MEMORANDUM

REVIEW TYPE: Preliminary Plan of Subdivision

PROJECT NAME: Midtown Silver Spring

CASE NO. 120060540

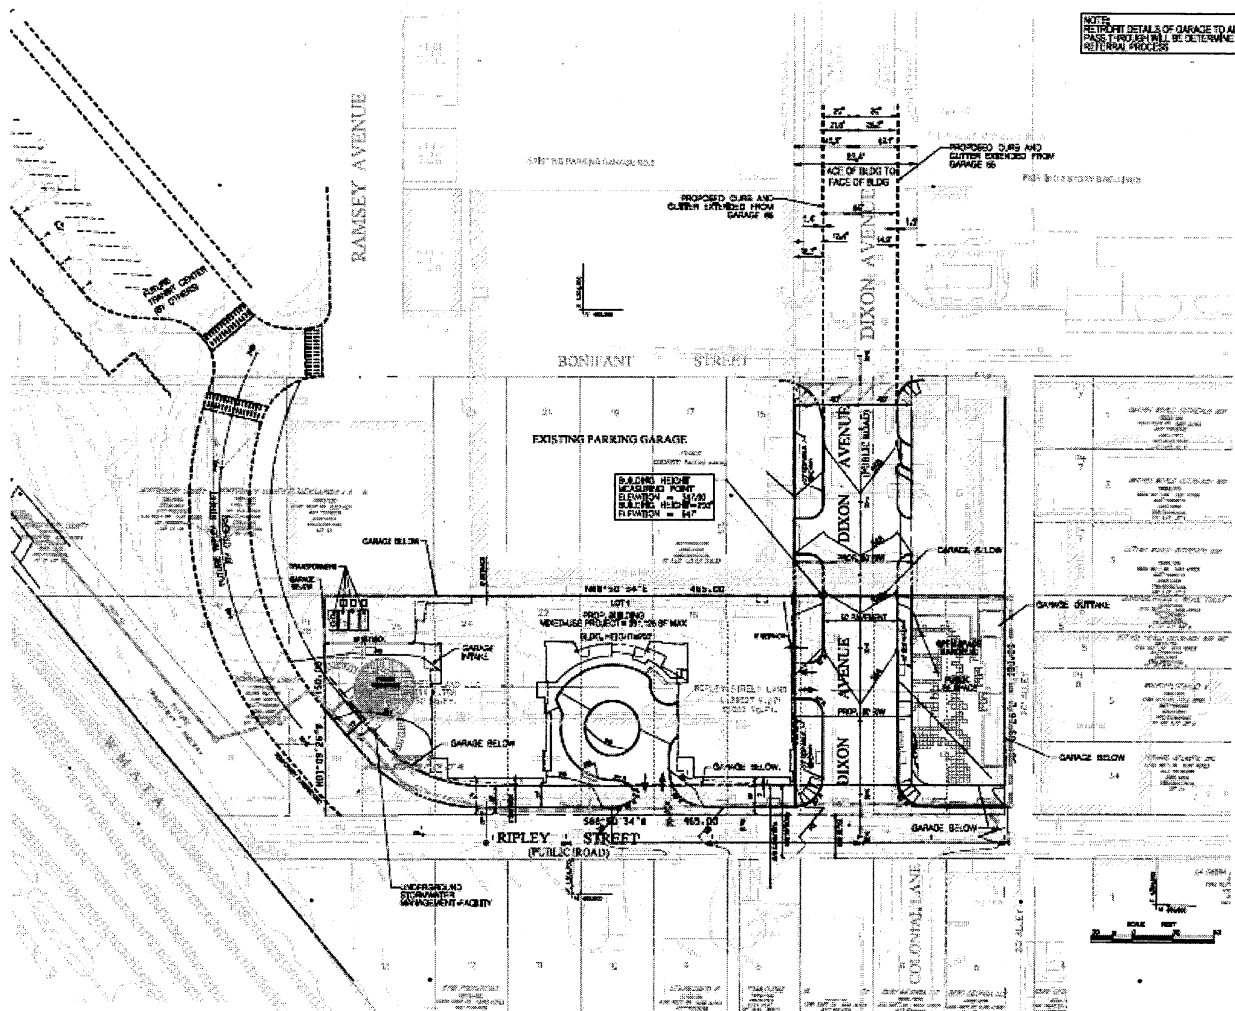
This preliminary plan illustration, shown below, proposes a 391,125 square foot, two-tower, 20-story (200 foot), "U" shaped residential building containing 317 multi-family units and approximately 5,380 square feet of ground floor retail uses, including 369 underground parking spaces. The plan proposes that 39.25% of the site will be public open space with public amenities such as a plaza, landscaping, public art, benches and special lighting. Significant improvements to Ripley Street, the public garage and Dixon Avenue are also proposed as part of the Project Plan and will be appropriately reviewed as part of the required site plan review. Ripley Street will continue around the southwest corner of the property to eventually be extended by other projects into the Silver Spring Transit Center. This project makes the necessary on-site dedications to accommodate that eventual connection.

Corner Truncation

The preliminary plan does not show required dedication for truncation at the corners of Dixon Avenue and Ripley Street. Pursuant to Section 50-26(E)(3) of the Subdivision Regulations, a 25 foot truncation at the corners must be shown as part of the dedication for right-of-ways to accommodate safe sight distance and, if necessary, traffic channelization. In this case there will be no traffic channelization other than a standard curbed corner with appropriate radii. Staff presumes, therefore, that the truncation is to accommodate safe sight distance.

MCDPWT did require truncation as a comment at the time of the Development Review Committee. In their approval memorandum dated March 17, 2007, MCDPWT made no suggestion that they supported waiving the truncation. Further, the applicant has not demonstrated, through a waiver request, that a demonstrated practical difficulty or unusual circumstance exists for the Planning Board to consider waiving the truncation, pursuant to Section 50-38 of the Subdivision Regulations. Therefore, staff recommends that there be a condition to dedicate the necessary truncation as part of the preliminary plan approval. At the time of site plan review, staff will have the ability to review a revised building layout that respects the truncation line, or if at that time, the applicant can demonstrate that a practical difficulty or unusual circumstance exists, the Planning Board may be in a position to waive truncation. The preliminary plan would need to be amended to remove the condition for truncation prior to action on the site plan.

- 12) Applicant must dedicate 25 foot truncations at all intersections. Revise building locations accordingly.
- 13) No clearing, grading or recording of plats prior to certified site plan approval.
